Ref: 29011.00

Re: MDP and Site Plan Phase 1 Comments
Silo Ridge Resort Community
Amenia, NY

On behalf of our client, Silo Ridge Ventures, LLC., "the Applicant", VHB Engineering, Surveying and Landscape Architecture, P.C. (VHB) offers the following responses to your comments dated October 17, 2014 (numbered in accordance with your letter).

Not Approved for Construction
Drawing Title
General Plan 6

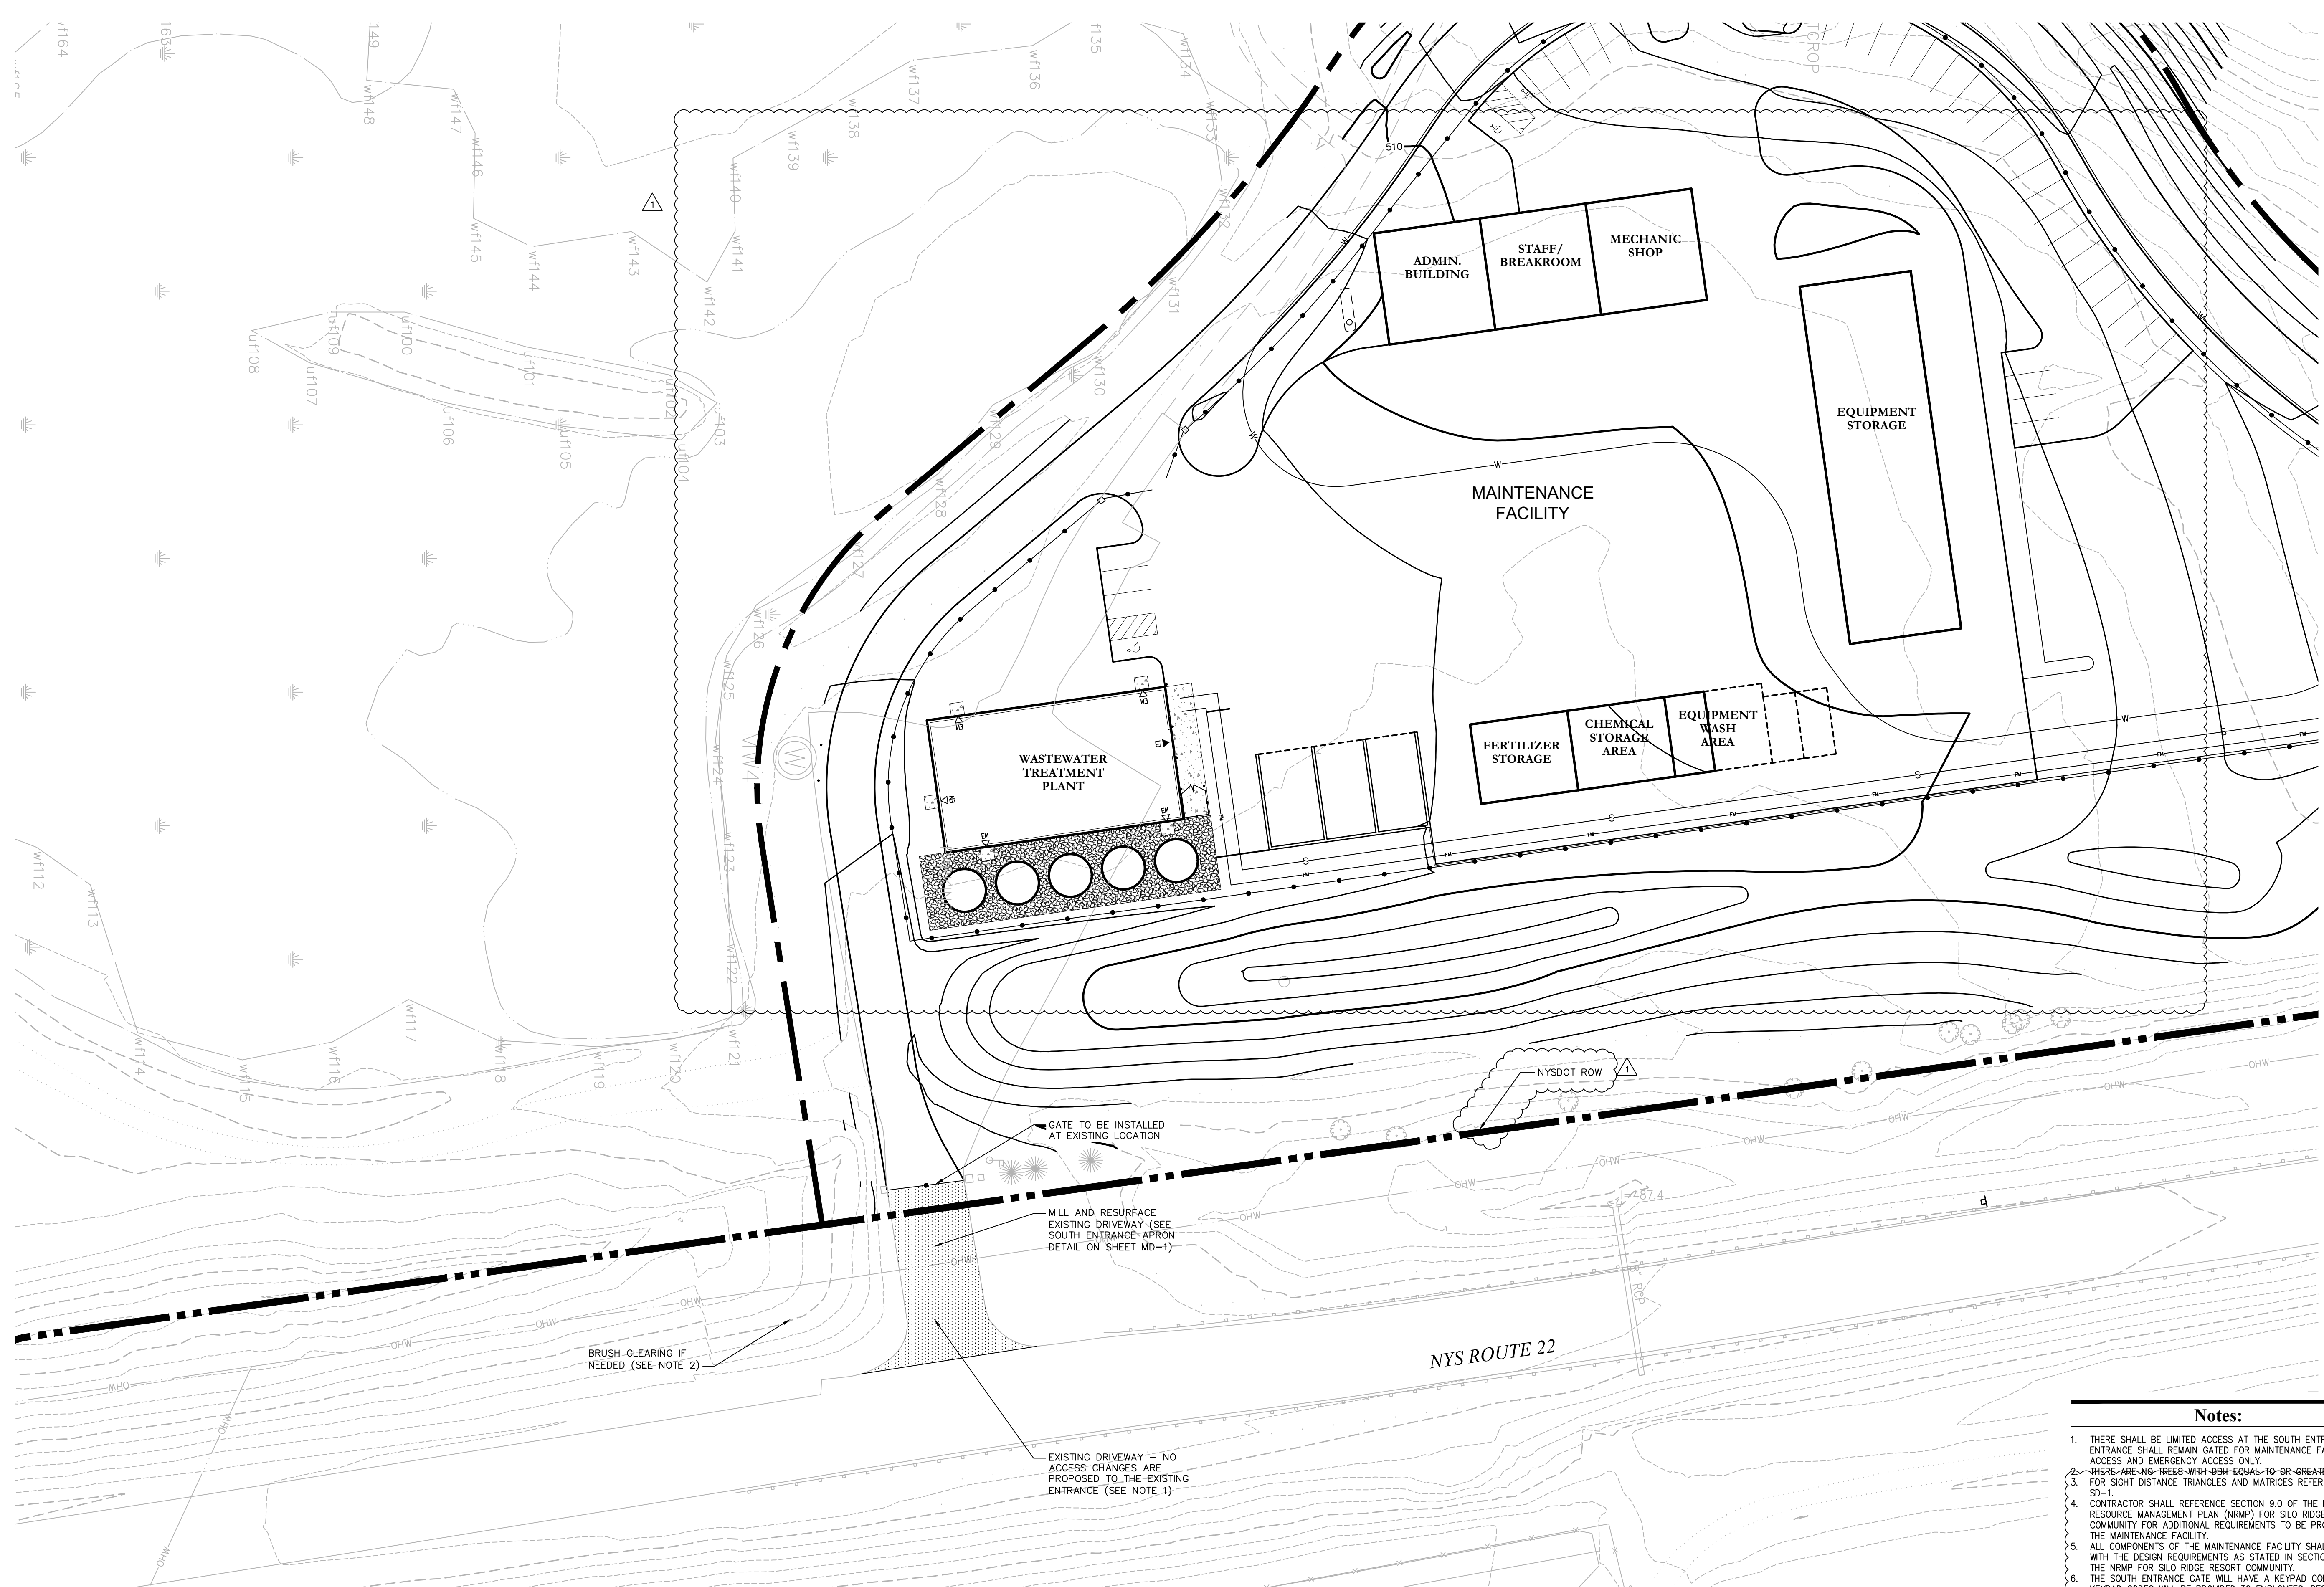
10. Comment: Please offer confirmation that the gate shown on drawing GP-7 is on private lands.

14. Comment: Information on the culvert under RTE 22 at the southern end should be provided.

Response: The gate shown on drawing GP-6 (formerly GP-7) is on private lands, as indicated by its location relative to the right-of-way boundary line on drawing GP-6, General Plan 6, dated January 8, 2015).

Response: Existing information for the 18” RCP pipe under Route 22 at the south entrance has been added to the plan, please refer to Drawing, GP-6.

Miscellaneous Details 1

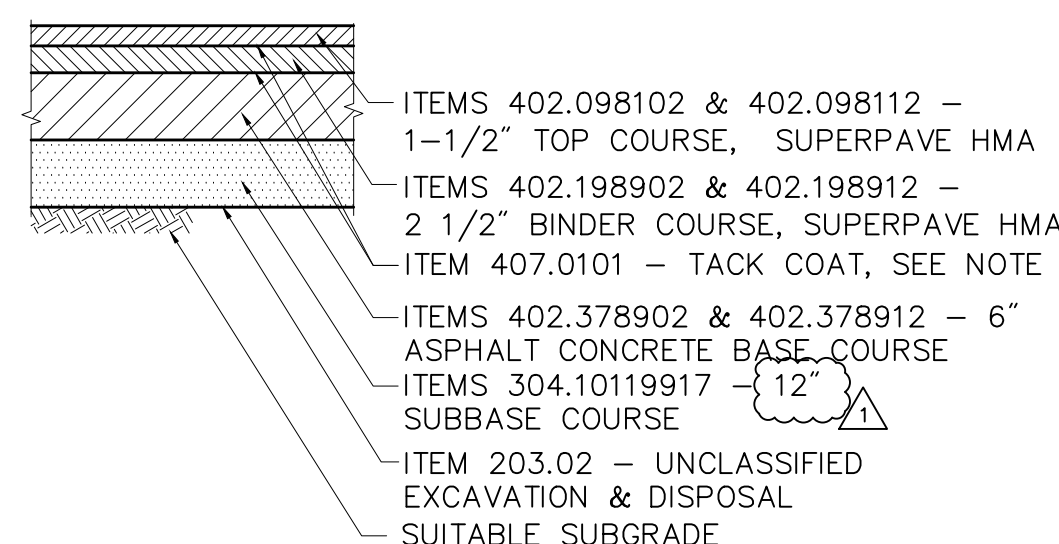
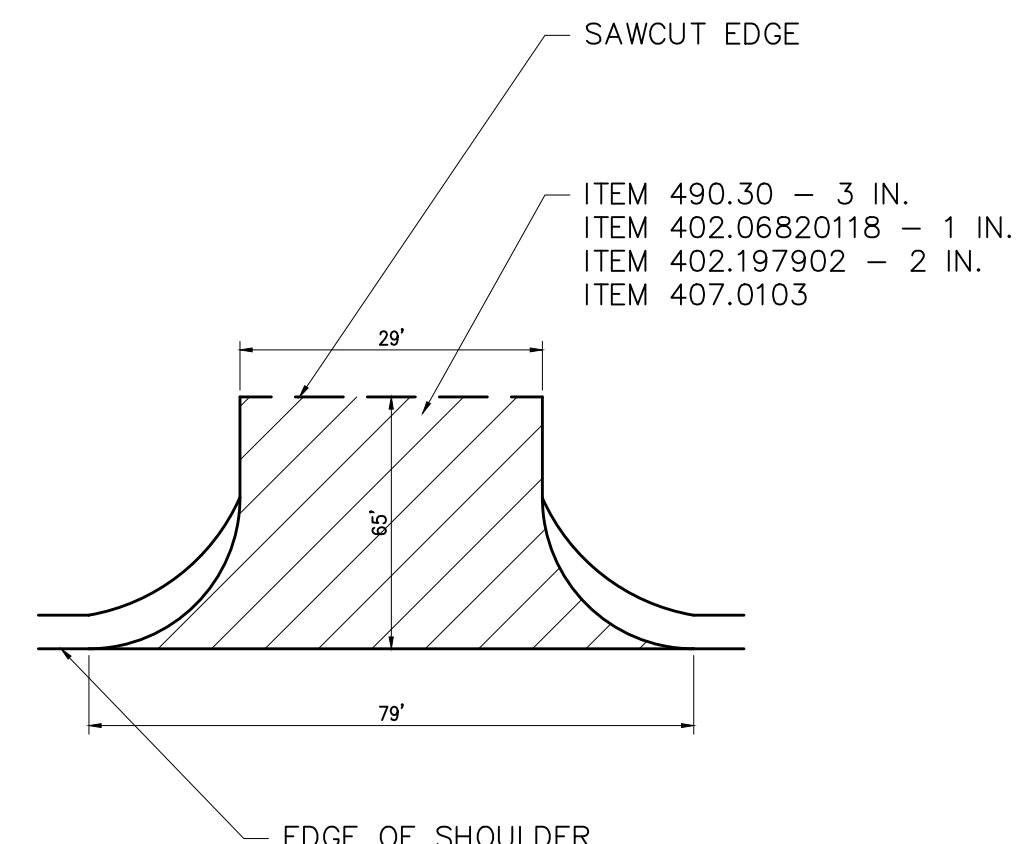
22. Comment: Align the detail for pavement thickness for work on State highways with standard details.

Response: The detail for pavement thickness for work on State highways has been aligned with the standard details, please refer to sheet MD-1, Miscellaneous Details 1, dated January 8, 2015.

Drawing Number
MD-3
Sheet of 16 18
Project Number
29011.00

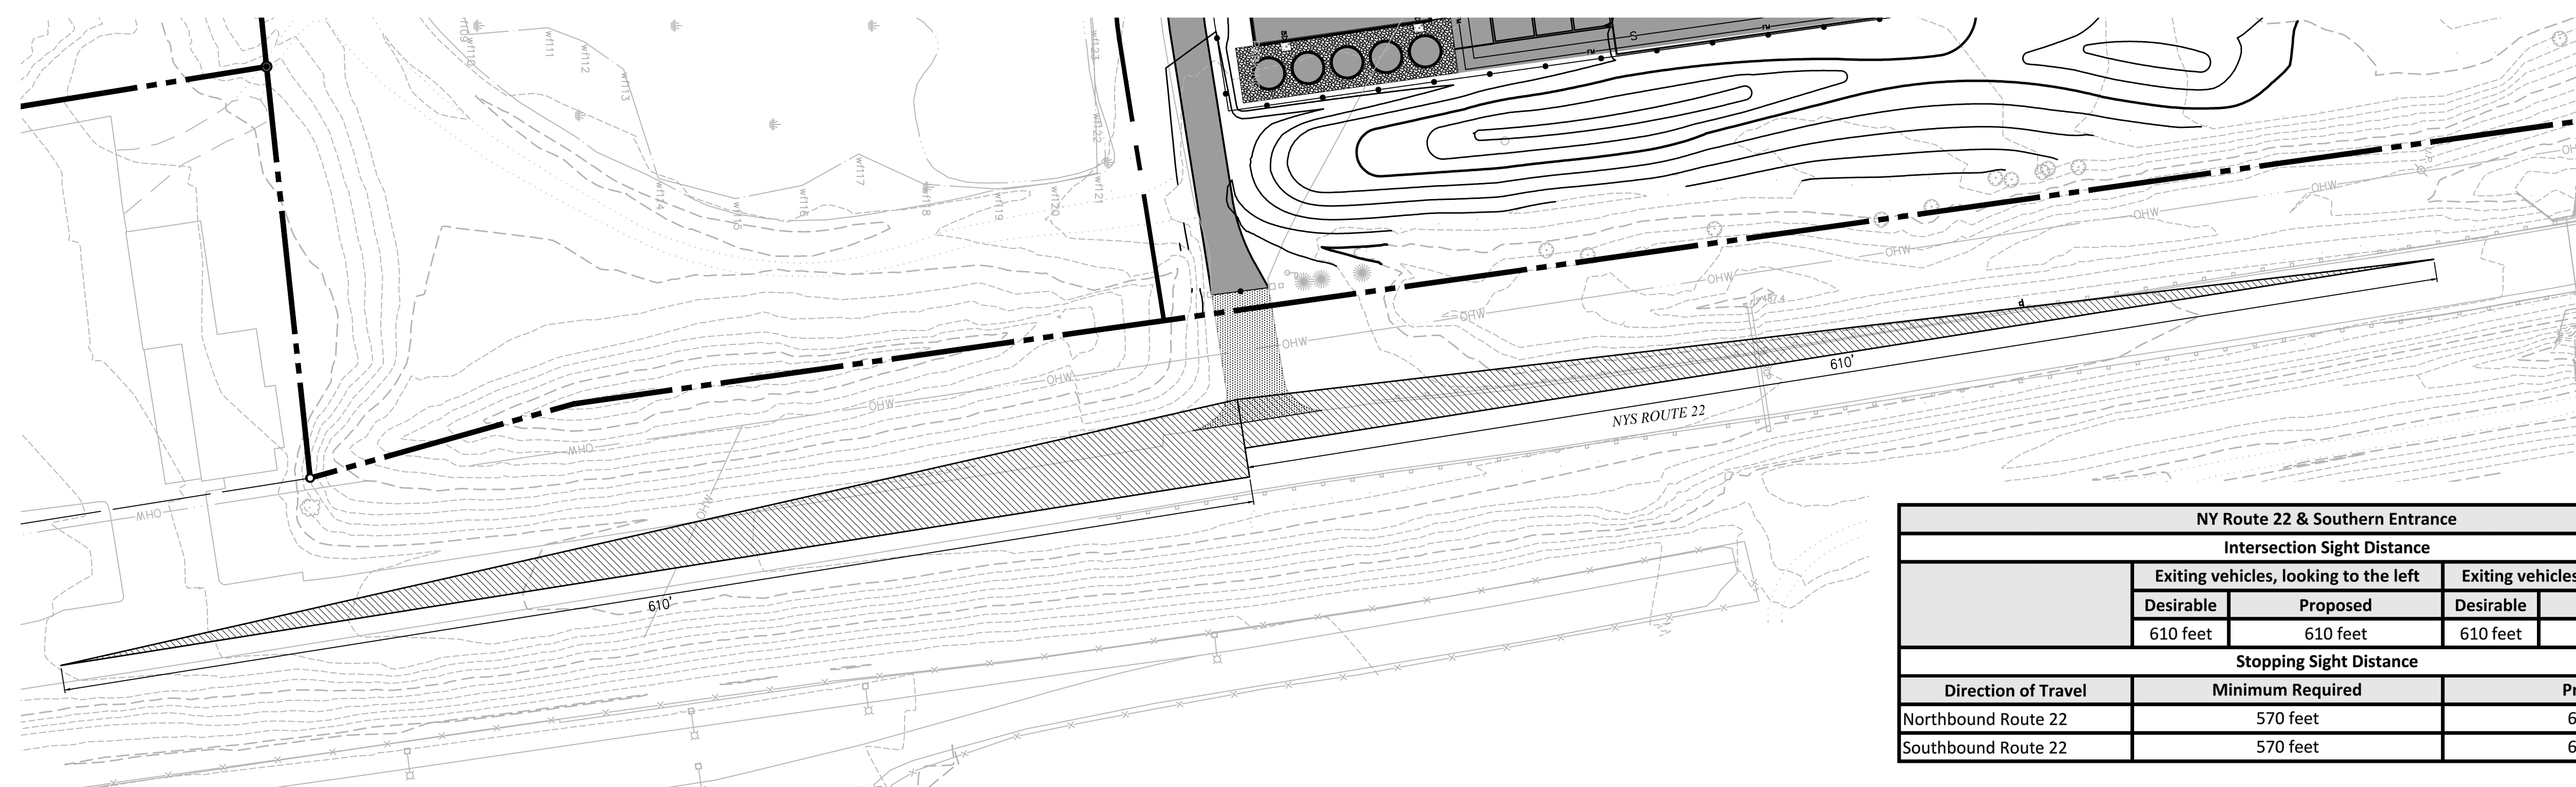
3. Comment: At one time, it was understood that a fill operation was planned within the right-of-way at either side of the main entrance. This is not evident on the plans. A confirmation is requested.

Miscellaneous Details 3, dated January 8, 2015. The applicant intends to import the necessary fill along Route 22 which will adhere to the local, state and federal requirements accordingly, however, if fill from within the project site is intended to be used, it will be testing to assure compliance with all applicable standards.

SD-1

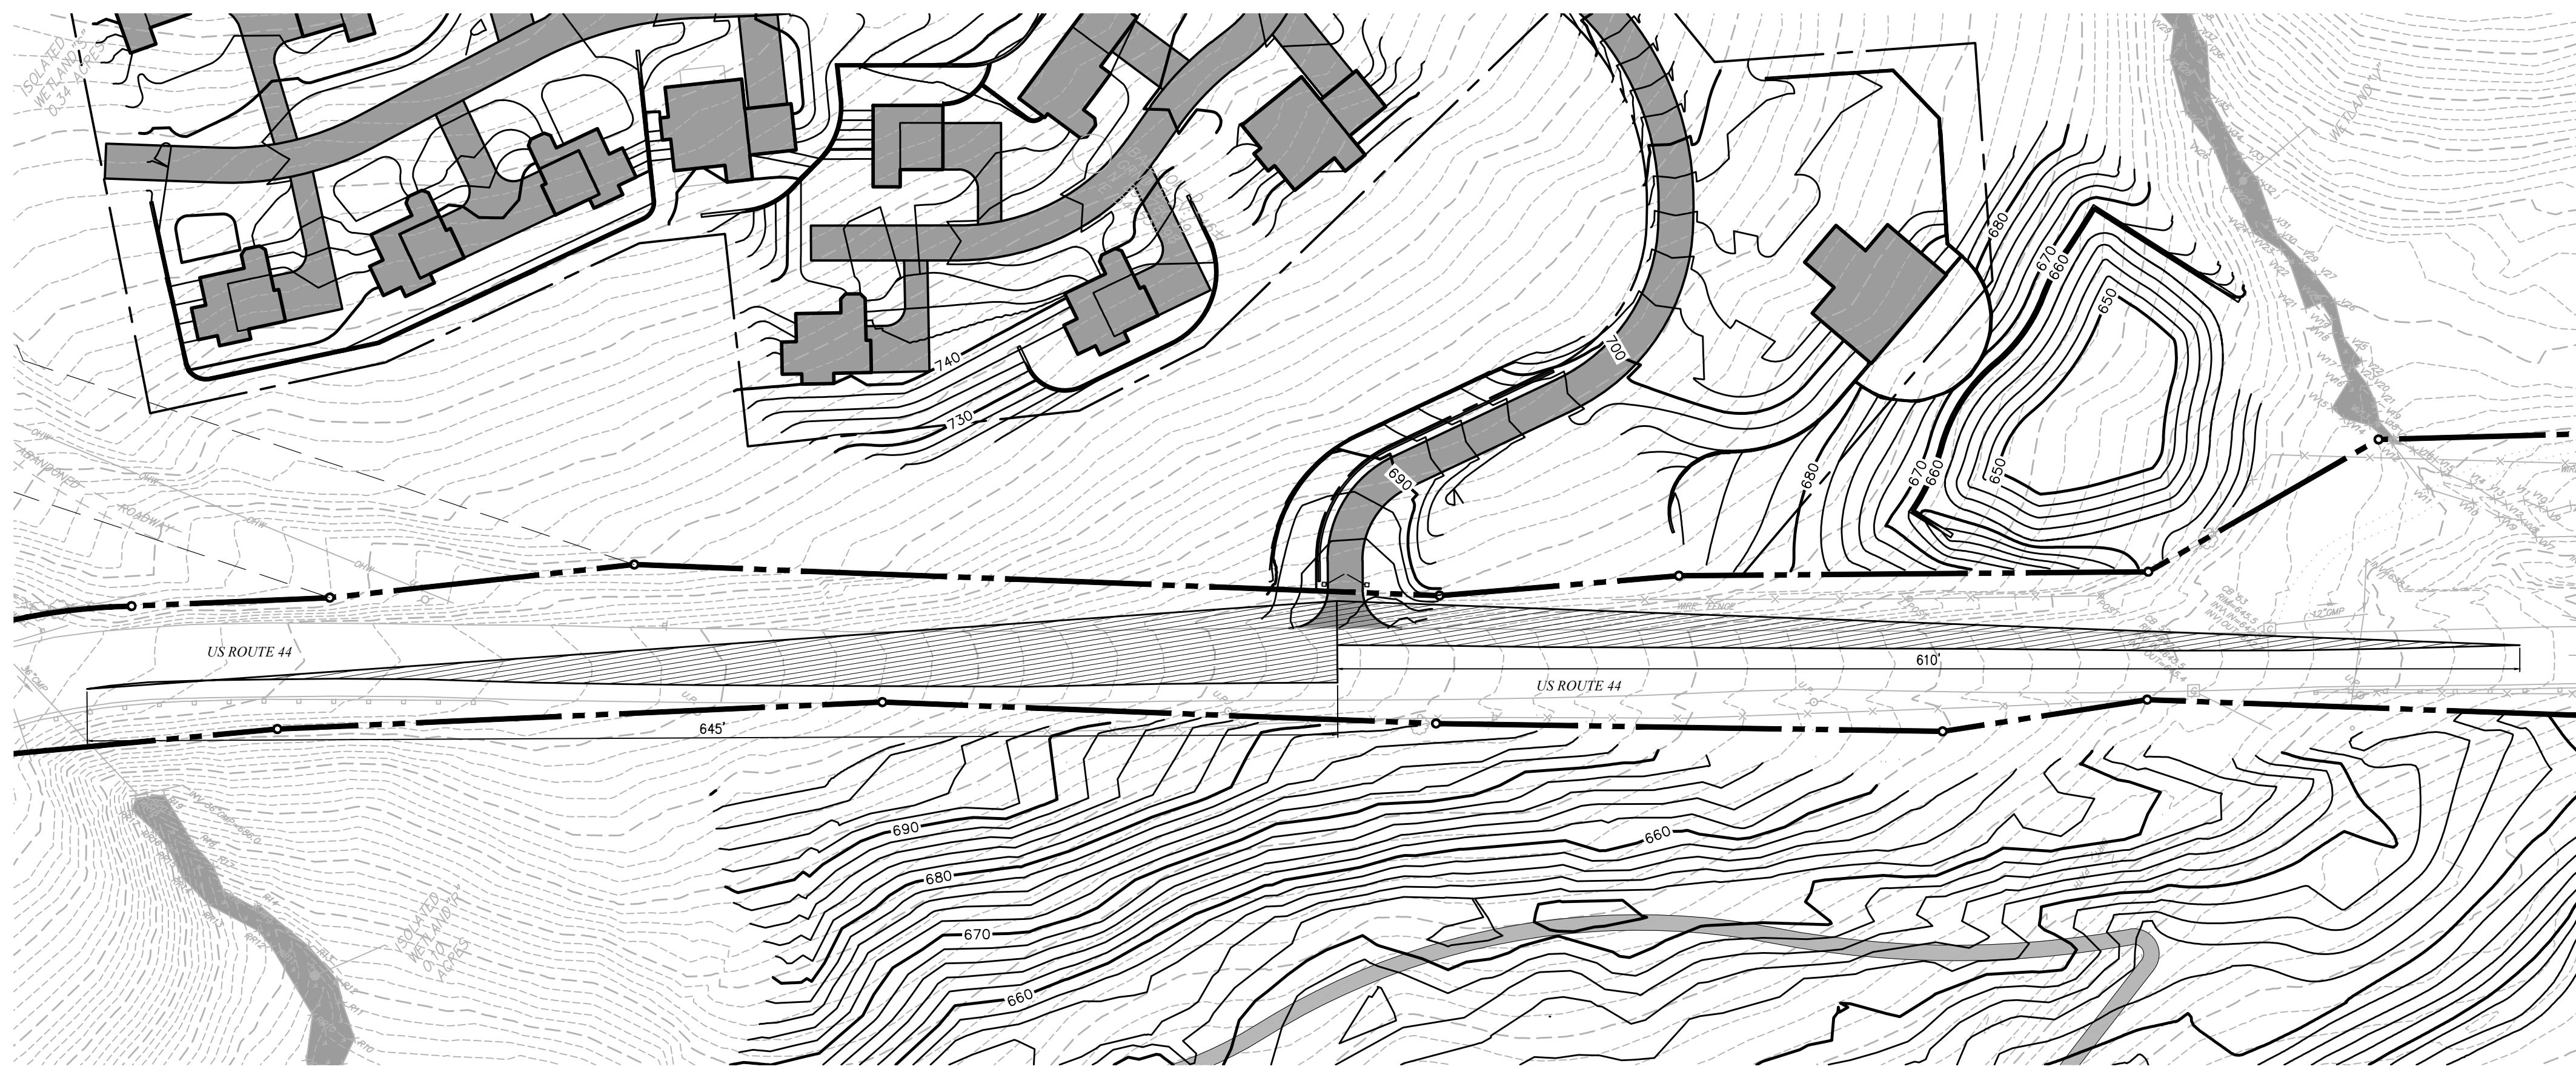
5. Comment: Show sight distance triangles on the plans for all turning movements at all entrances. Provide a matrix at each location detailing required sight distance for each type of movement and available sight distance.

Response: Sight distance triangles and matrices indicating available and required sight distances at each location have been included on Drawings SD-1 and SD-2, dated January 8, 2015.
